STAFF REPORT
COMMUNITY DEVELOPMENT DEPARTMENT

SUBJECT: H-2021-0065
 Aviator Springs – AZ, PP

LOCATION: 3235 N. McDermott Rd., in the SE ¼ of Section 32, T.4N., R.1W. (Parcels #R7824220044 & #R7824220042)

B. Preliminary Plat & Phasing Plan (date: 9/3/2021-12/2/21) - Revised

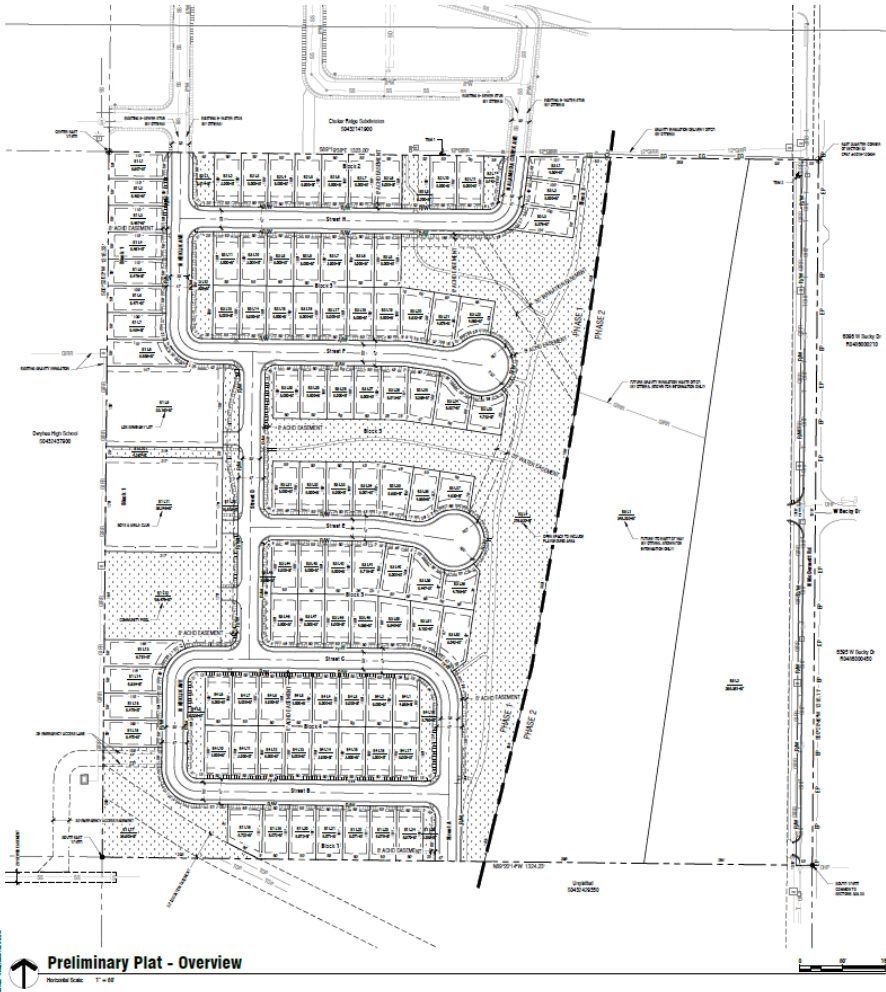
The proposed preliminary plat consists of a total of 112 lots consisting of (93) buildable lots and (13) common open space lots on ~~31.59~~ 27.63 acres of land in the R-8 zoning district; (2) buildable lots on 1.64 acres of land in the L-O zoning district; (1) buildable lot on ~~6.77~~ 10.72 acres of land in the M-E zoning district; and (3) future right-of-way lots on 40 acres of land for Aviator Springs Subdivision. The future ROW for SH-16 totals 7.9 acres and the McDermott ROW is 0.8 of an acre.

The subdivision is proposed to develop in two (2) phases as shown on the preliminary plat. The first phase will contain the land on the west side of future SH-16 and the second phase will contain the land on the east side.

C. Landscape Plan (date: 9/3/2021)

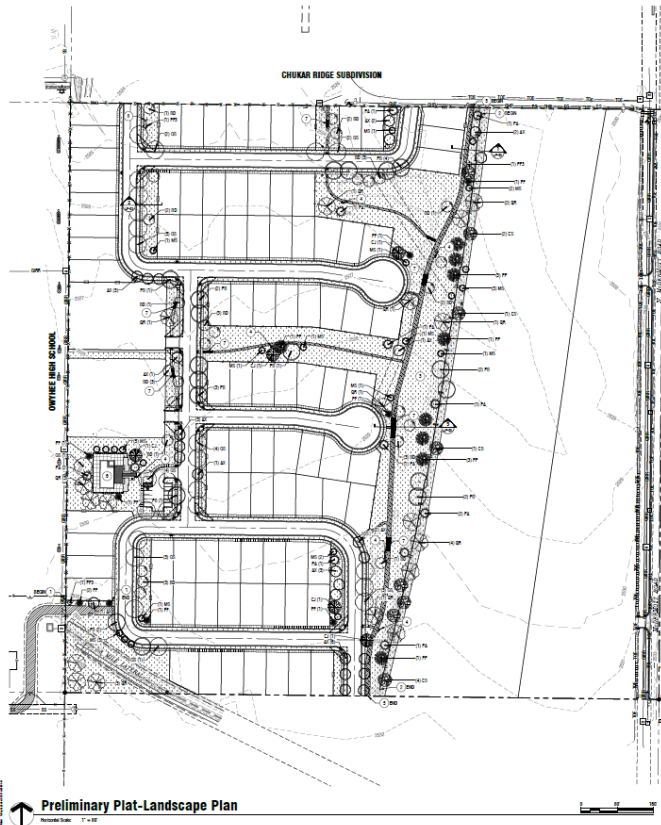
A 35-foot wide street buffer is required on both sides of future SH-16, a state highway and entryway corridor. Landscaping is required to be installed within the buffer per the standards listed in [UDC 11-3B-7C](#), which require a *mix* of trees and shrubs, lawn, or other vegetative groundcover – shrub should be included in the buffer in accord with this standard. A dense buffer is proposed on the west side of future SH-16 consisting of a mix of deciduous & coniferous trees; **shrubs should be added as required by UDC 11-3B-7C. No buffer is depicted on the east side of future SH-16; a minimum 35-foot wide street buffer is required in a common lot or a permanent dedicated buffer with landscaping included on the landscape plan in accord with UDC standards.**

Common open space is required to be landscaped in accord with the standards listed in UDC 11-3G-3E. At a *minimum*, one tree per 8,000 square feet of common area is required to be provided along with lawn or other vegetative groundcover. Landscaping is proposed in *excess* of UDC standards as shown on the landscape plan in Section VII.C.

Landscaping is required adjacent to all pathways per the standards in UDC [11-3B-12C](#). A 5' wide landscape strip is required on both sides of pathways planted with a *mix* of trees, shrubs, lawn and/or other vegetative ground cover. **The Landscape Requirements table should include the linear feet of pathway with the required vs. proposed number of trees to demonstrate compliance with UDC standards.**

Noise abatement is required for residential uses adjoining a state highway. A berm or berm and wall combination is required to be constructed parallel to the state highway that meets the standards listed in UDC 11-3H-4D. A 6-foot tall fence/wall is proposed on the landscape plan that does *not* meet the required standards as there is no berm proposed.

In accord with City Council's direction on previous developments to the north (i.e. Chukar Ridge & Gander Creek subdivisions), Staff recommends a 6-foot tall berm with a 6-foot tall wall on top of the berm is constructed within the buffer along future SH-16. The berm/wall is required to be a minimum of 10-feet higher than the elevation at the centerline of the state highway; the wall must meet the standards in UDC 11-3H-4D.3. A detail of the proposed berm/wall combination that demonstrates compliance with the standards listed in UDC 11-3H-4D and as recommended by Staff should be submitted with the final plat for the first phase of development after the Commission hearing. *Alternative compliance may be approved by the Director as set forth in UDC 11-5B-5 where the applicant has a substitute noise abatement proposal in accord with ITD standards and prepared by a qualified sound engineer per UDC 11-3H-4D.4.*

- b. Include a note prohibiting access to future SH-16.
 3. The landscape plan submitted with the final plat shall be revised as follows:
 - a. Add Class II trees and landscaping within all parkways within the development in accord with the standards listed in UDC 11-3A-17E and 11-3B-7C as desired in MU-N designated areas.

- d. Include a detail of the berm or berm and wall combination required for noise abatement along future SH-16 that demonstrates compliance with the standards listed in UDC 11-3H-4D and is consistent with what City Council required on previous developments to the north (i.e. Chukar Ridge & Gander Creek – a 6-foot tall berm with a 6-foot tall wall on top of the berm); or apply for alternative compliance as allowed by UDC 11-3H-4D.4 as set forth in UDC 11-5B-5.

E. Parking Exhibit

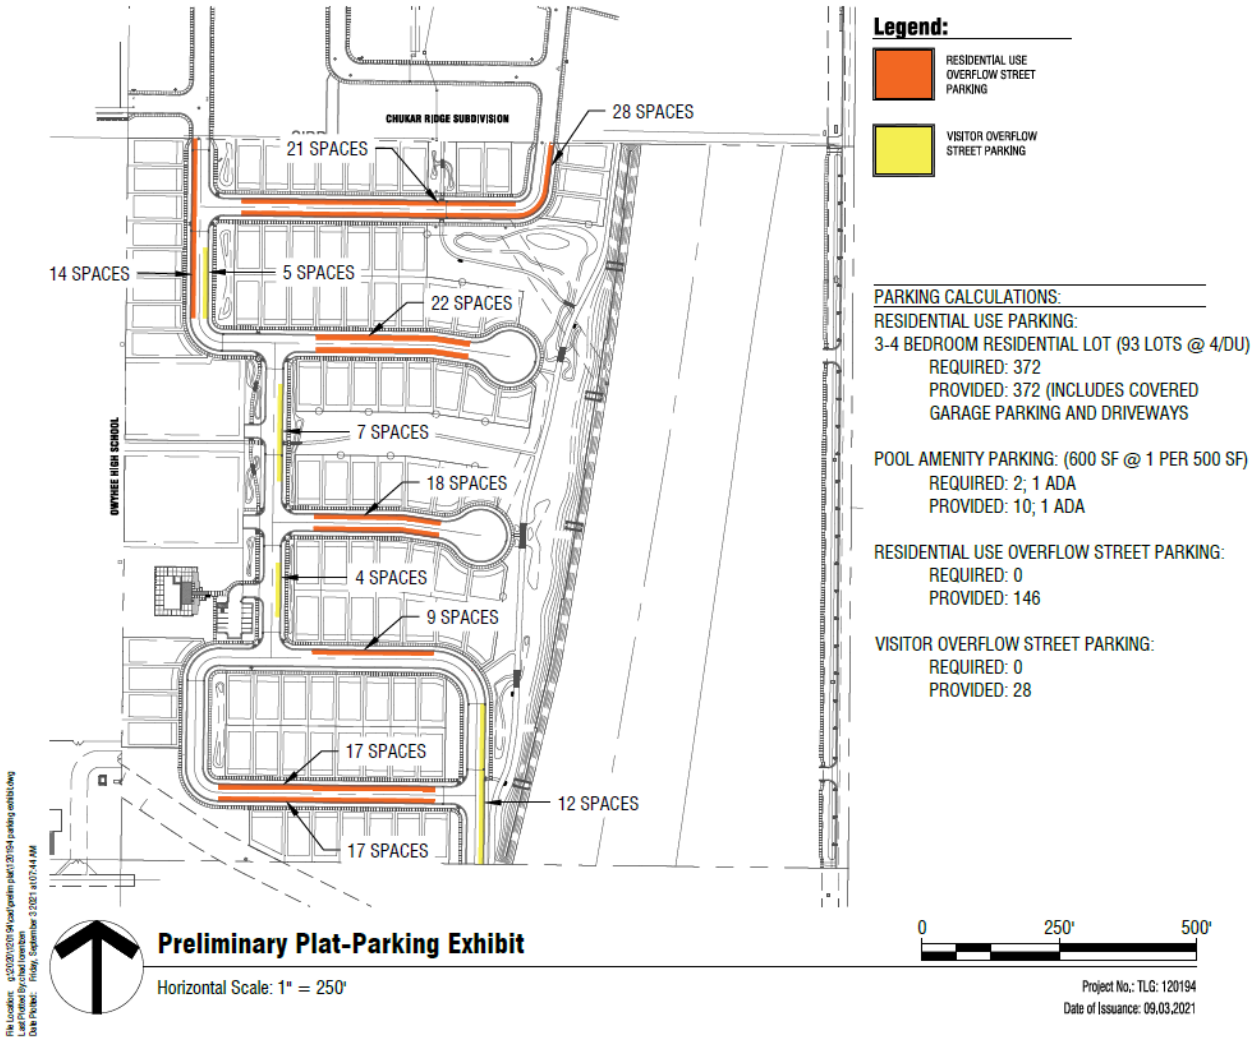
The proposed street sections accommodate on-street parking on both sides of the streets for guests in addition to driveway parking spaces on each lot; 146 spaces are proposed for guests in the residential area along with another 28 spaces as depicted on the parking plan in Section VII.E. Staff is of the opinion sufficient parking can be provided for this development.
